AUG 11 2011
L-2011-277
10 CFR 50.90

Re: Turkey Point Units 3 and 4
Docket Nos. 50-250 and 50-251
Confirmatory Dose Assessment for Control Room Emergency Ventilation
System Air Intake Modification to Satisfy Operating License Conditions
3.H.1 for DPR-31 and 3.I.1 for DPR-41

**CONFIRMATORY DOSE ASSESSMENT
FOR CONTROL ROOM EMERGENCY VENTILATION SYSTEM
AIR INTAKE MODIFICATION TO SATISFY
OPERATING LICENSE CONDITIONS
3.H.1 FOR DPR-31 AND 3.I.1 FOR DPR-41**

Figure 1: Routing and Location of CREVS Air Intakes

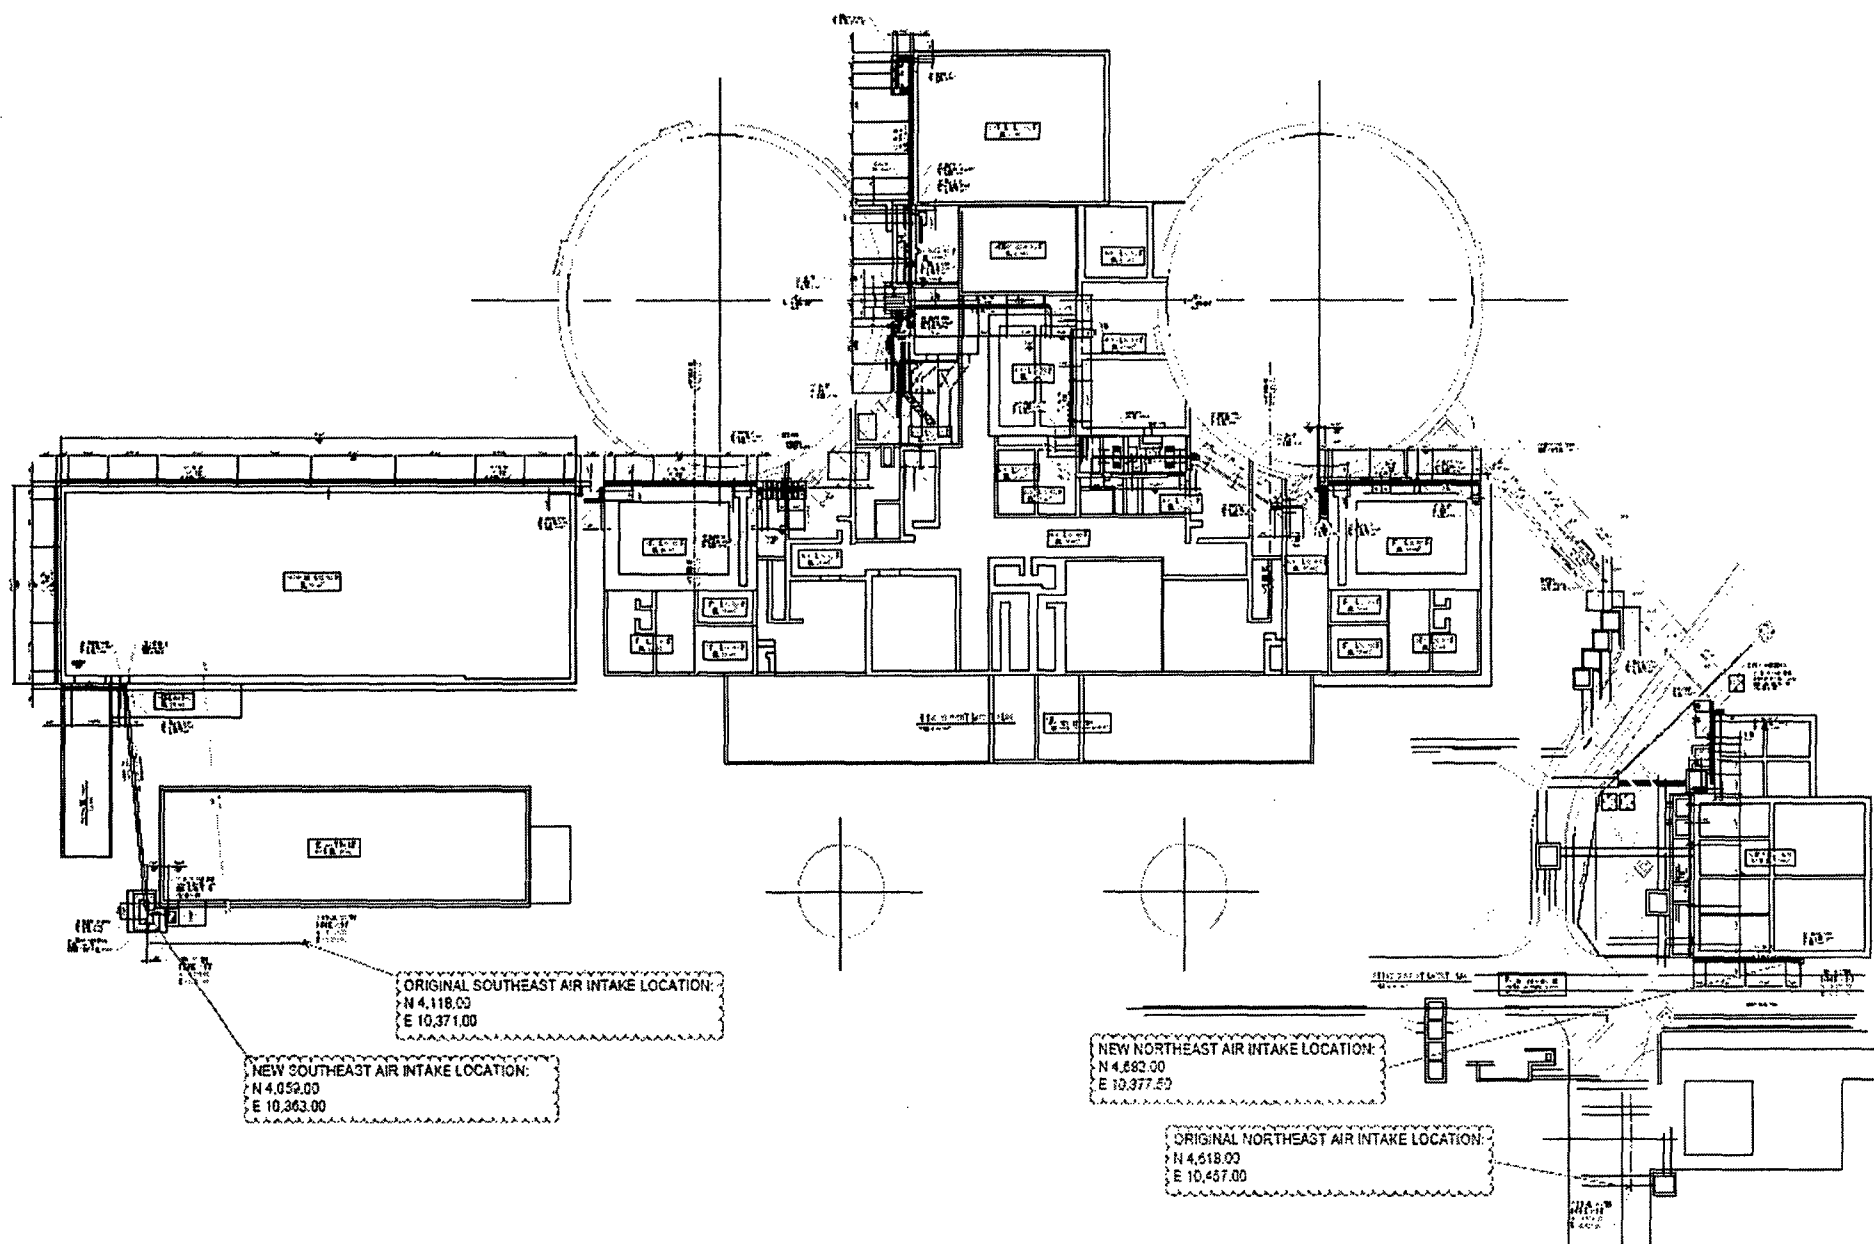
During the relocation of the control room emergency air intakes construction interferences were encountered that resulted in changes to the original intended design locations for the Southeast and Northeast air intake structures. These changes in the location of the air intake structures caused recalculation of the onsite atmospheric dispersion factors (X/Qs) and design basis accident dose consequences. The net impact of these changes on the radiological dose consequences was a small increase in the integrated control room dose except in the cases of LOCA, FHA, and RCCA Ejection – Containment Release where the dose consequences decreased.

As indicated in Figure 1, the final location of the Southeast air intake was moved some 8 ft West and 59 ft further South of its originally indicated position to the Southeast corner of the access and dress facility at Elevation 24 ft. The final location of the Northeast air intake was moved some 84 ft West and 64 ft further North of its originally indicated position to the Northeast corner of the Unit 4 emergency diesel generator building at Elevation 38 ft. Although the Southeast air intake is still considered limiting for the dose analyses, the actual differences in X/Q values for the two air intakes is now much closer. The resulting onsite X/Qs used in the accident analyses are provided in Table 1. The revised integrated 30 day control room radiological doses and the resulting dose differences from those reported in Reference 3 are provided in Table 2. The methodology used in the confirmatory dose assessment is the same as that previously used for AST Amendments 244 and 240 including the methods used for the establishment of the X/Qs. The integrated control room radiological doses continue to be well within the limits established in 10 CFR 50 Appendix A GDC-19.
